T32MZ SOFTWARE UPDATE CHANGES

(Editor Version: 3.3.1 Encoder version: 1.2)

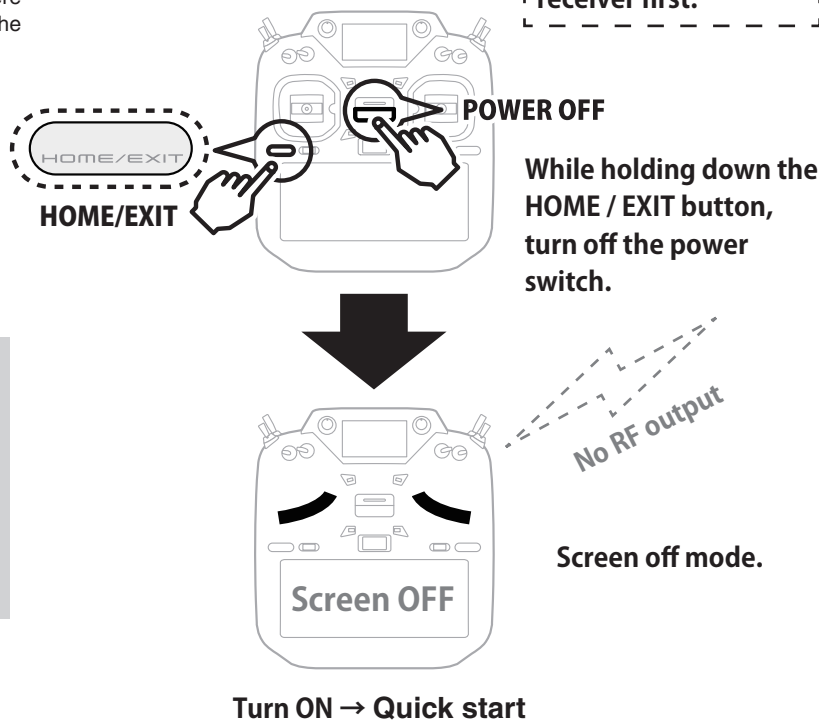
1. Add Screen off function [Quick start]

This "screen off" can quick start next startup. This is convenient when turning on and off frequently. No RF output at "screen off". Also, there is no screen display. However, the battery is consumed because the internal circuit is activated.

Be sure to turn off the receiver first.
